Project:	**C9727 - I-405, Brickyard to SR 527 Improvement Project**
Document Name:	**BY-CRE-03898_009727_SUB_18.05_Load Rating Report - NW-12 Culvert**
Submittal Date:	**11/12/2025**
Due Date:	**11/26/2025** **COB**
Reviewer:	**Terry Bondy (TB); Jason Pang (JP)**
Document Lead:

Formal Design Review
Form RCSR (Review Comment Summary and Resolution)

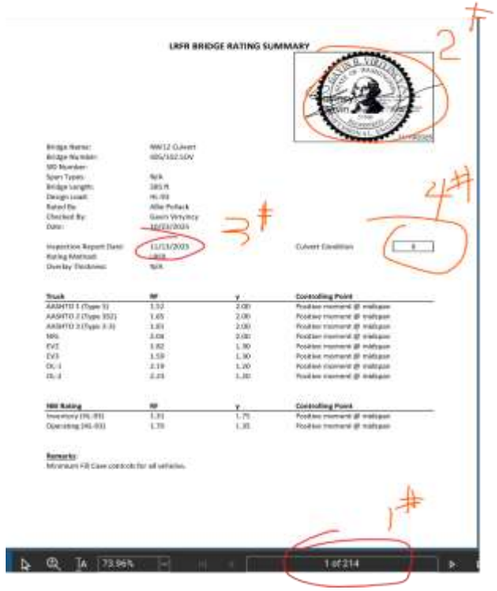
4	PDF Sheet 5 of 216	TB/JP	BDM Ch. 13.4	Replace *Substructure Condition, Deck Condition, and Superstructure Condition* with *Culvert Condition.* Per WSDOT Inspection in November 2025, culvert condition is *6 - Satisfactory.*	A	AP	Revised on Load Rating Summary.Please image shot pasted left side of RCSR form	A	Comment addressed.	A
5	PDF Sheet 184 of 216	TB/JP	BDM Ch. 13	Add note stating that *4M Engineering's* supplementary calculations are included for the purpose of documenting the geometry and reinforcement.	A	AP	Added note to page 117 of PDF (page 114 of report).	A	Comment addressed.	A
6										
7										
8										
9										
10										
11										
12										
13										
14										
15										
16										
17										
18										
19										
20										
21										
22										
23										
24										
25										
26										
27										
28										
29										
30										
31

COMMENT (WSDOT, City, Checker)					RESPONSE TO COMMENT (Skanska, Originator of Document)			RESPONSE TO RESPONSE (WSDOT, City, Checker)		Skanska CLOSE
No.	Report or Sheet No.	Comment By	TR/Spec Section	Comment	Disposition Code	Response By	ACTION TAKEN / Remarks	WSDOT Disposition Code	Comments / Action Items	Final Disposition Code
1	PDF Sheet 5 of 216	TB/JP	BDM Ch. 13	Load Rating Summary Sheet should be first sheet in Load Rating Report.	A	AP	Load Rating Summary is now the first sheet in report. Please image shot pasted left side of RCSR form	A	Comment addressed.	A
2	PDF Sheet 5 of 216	TB/JP	BDM Ch. 13.4	Report PDF needs to be signed digitally and the PDF file locked. Please correct for RFC.	A	AP	Report PDF will be signed digitally and the PDF file will be locked for RFC. Please image shot pasted left side of RCSR form	A	Comment addressed.	A
3	PDF Sheet 5 of 216	TB/JP	BDM Ch. 13.4	Revise inspection report date to the date of the WSDOT inspection on November 13, 2025.	A	AP	Revised on Load Rating Summary.Please image shot pasted left side of RCSR form	A	Comment addressed.	A
